**ZONING AMENDMENT,
PLANNED UNIT DEVELOPMENT &
SUBDIVISION STAFF REPORT****Date: June 16, 2011**

<u>NAME</u>	Davis Companies, LLC
<u>SUBDIVISION NAME</u>	Summer Subdivision
<u>DEVELOPMENT NAME</u>	University Grande Apartment Complex
<u>LOCATION</u>	6133 & 6201 Old Shell Road and 75 & 79 West Drive (Southeast and Southwest corners of Old Shell Road and West Drive)
<u>CITY COUNCIL DISTRICT</u>	District 6
<u>PRESENT ZONING</u>	R-1, Single-Family Residential
<u>PROPOSED ZONING</u>	R-3, Multiple-Family Residential
<u>REASON FOR REZONING</u>	To allow parking associated with a proposed Multi-Family Residential development.
<u>AREA OF PROPERTY</u>	4 Lots/ 10.3± Acre
<u>CONTEMPLATED USE</u>	<p>Subdivision approval to create three legal lots of record from four legal lots; Planned Unit Development Approval to amend a previously approved Planned Unit Development to allow multiple buildings on a single building site, off-site parking and shared access; and Rezoning from R-1, Single-Family Residential District, to R-3, Multiple-Family Residential District, to allow an off-site parking lot for an apartment complex.</p> <p>It should be noted, however, that any use permitted in the proposed distr

SITE PLAN

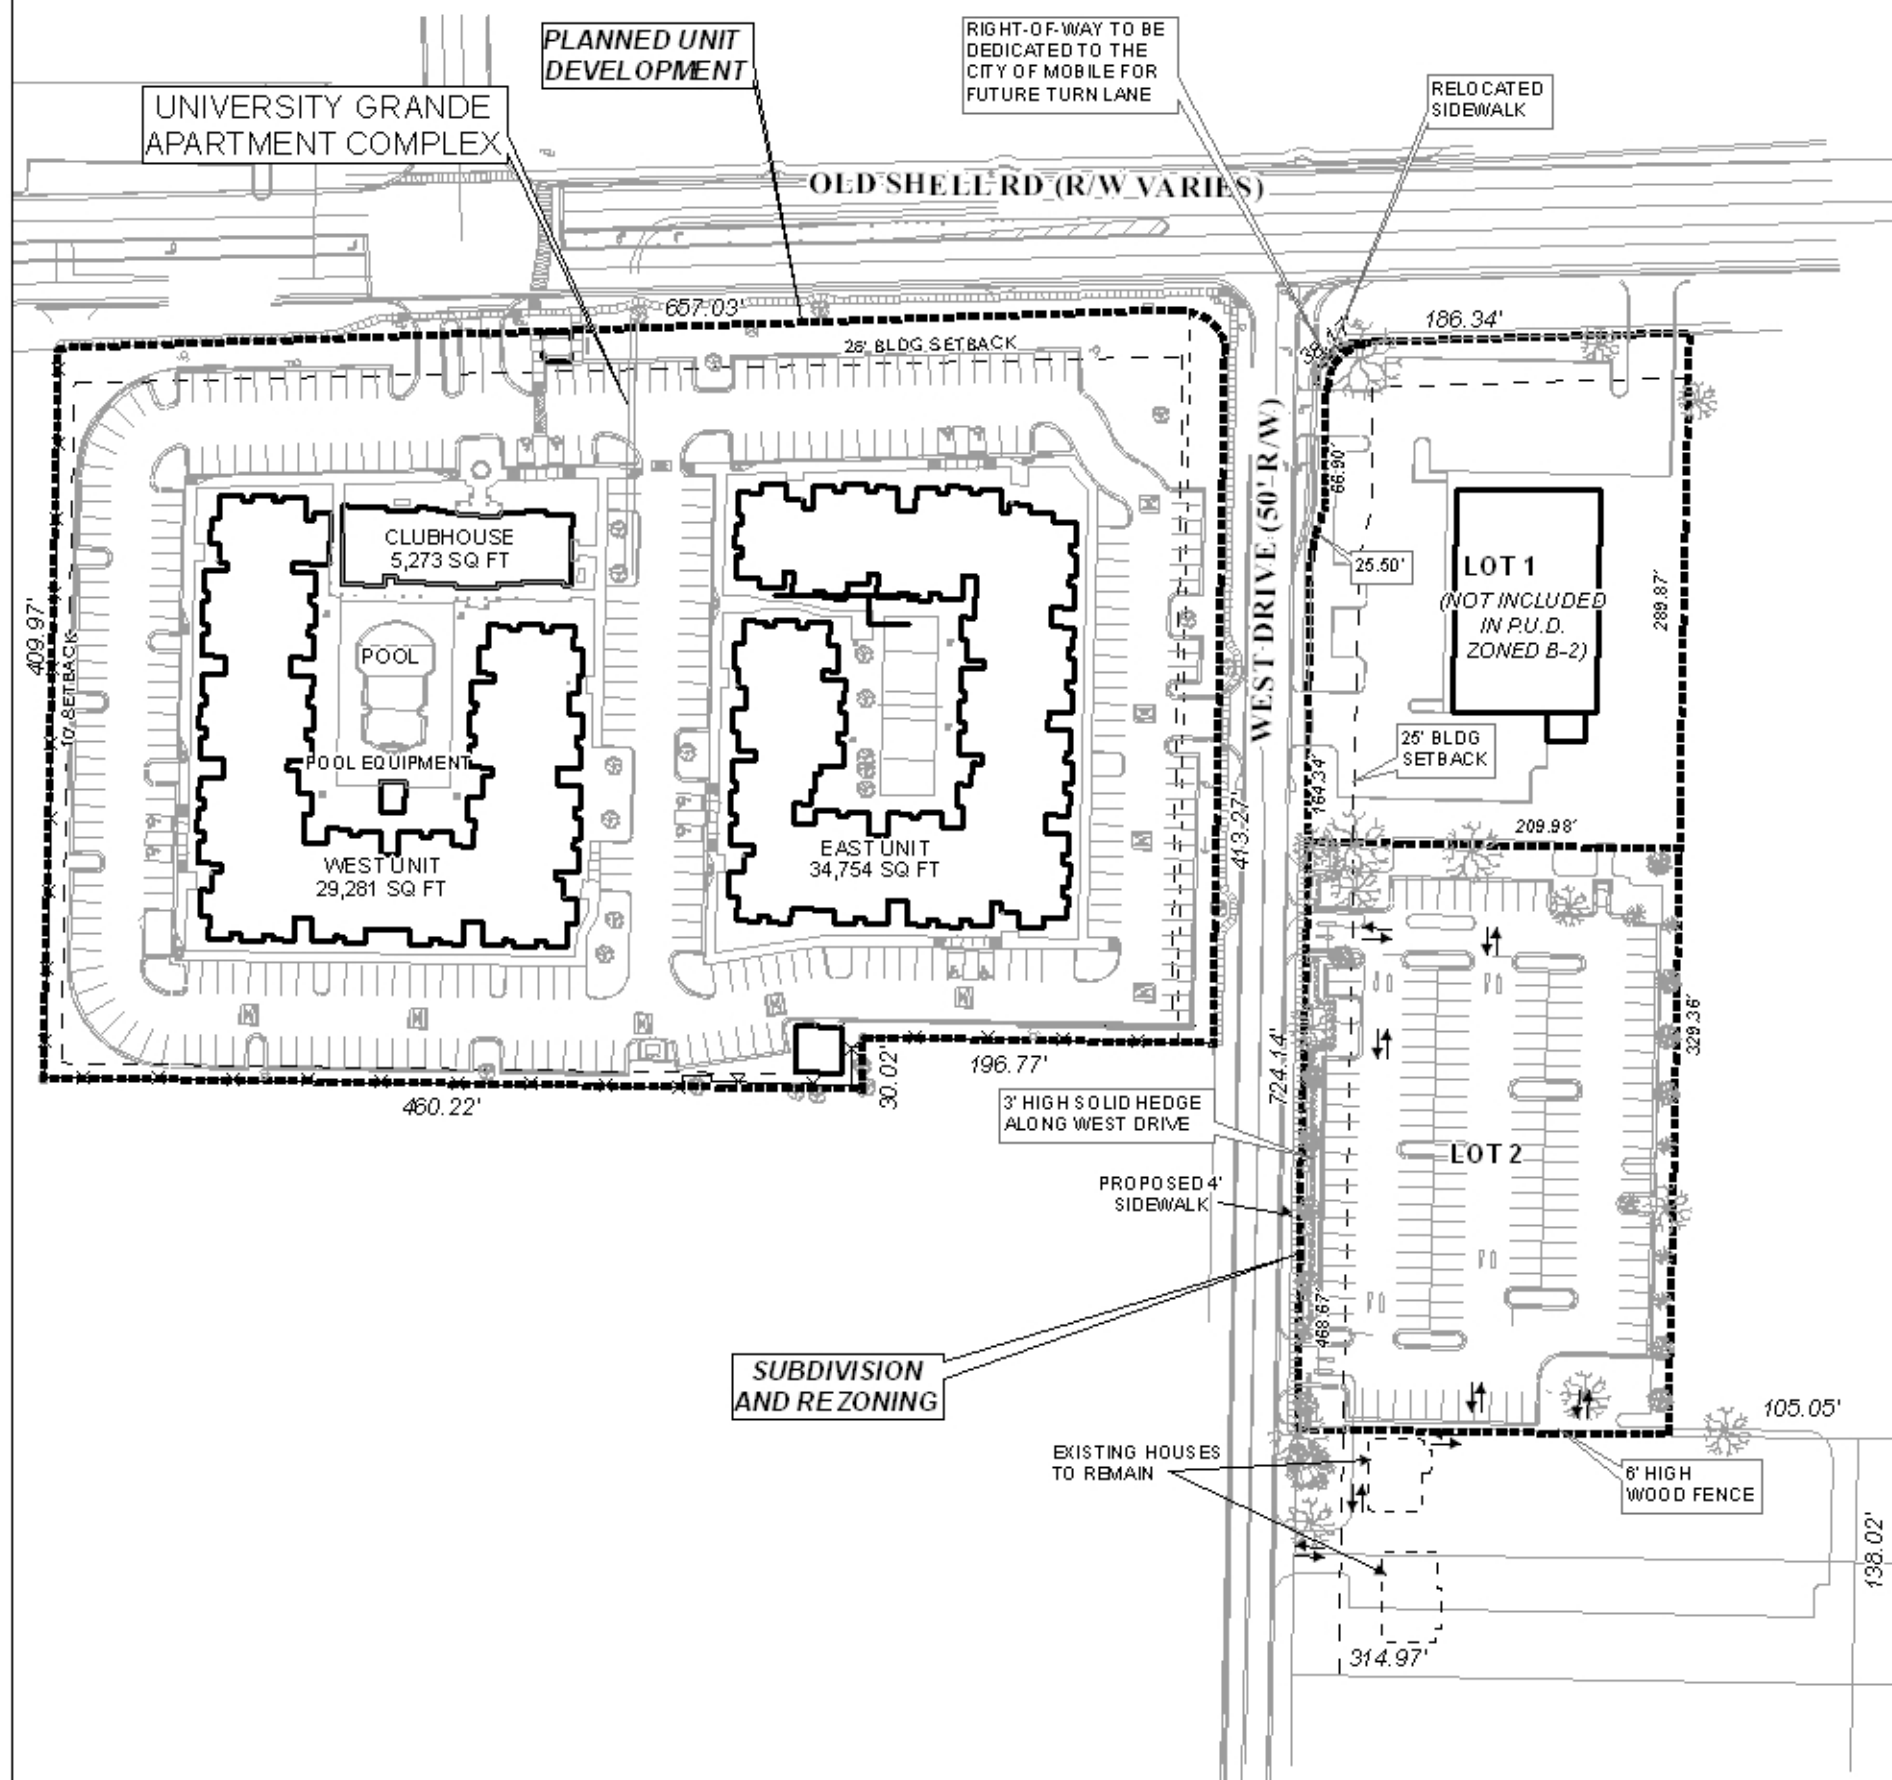
Property to be developed in compliance with state and local laws that pertain to tree preservation and protection on both city and private properties (State Act 61-929 and City Code Chapters 57 and 64). Tree removal permits are required from Urban Forestry before removing or trimming 24" DBH or larger Live Oak Trees. Coordinate with Urban Forestry to revise site plan to save 30" Live Oak Tree labeled "To Be Removed"

As proposed the applicant is illustrating a 15-foot landscape buffer, the plan does not illustrate a 6-foot high solid wooden fence as required by the Zoning Ordinance for development adjacent to residential development. Also, the Zoning Ordinance requires a 3-foot high wall or hedgerow along West Drive.

One concern is the lighting of the parking facility. The photometrics indicate a level of bleed over onto the residential property to the south. The lights along that section of the parking facility should be shielded such that any bleed over is reduced.

The site plan has not been revised to save the 30" Live Oak Tree, nor has Urban Forestry advised that their comments have been amended.

The revised site plan also illustrates the 30-inch Live Oak mentioned as “To Be Removed” on the previous site plan be saved as recommended by Urban Forestry.
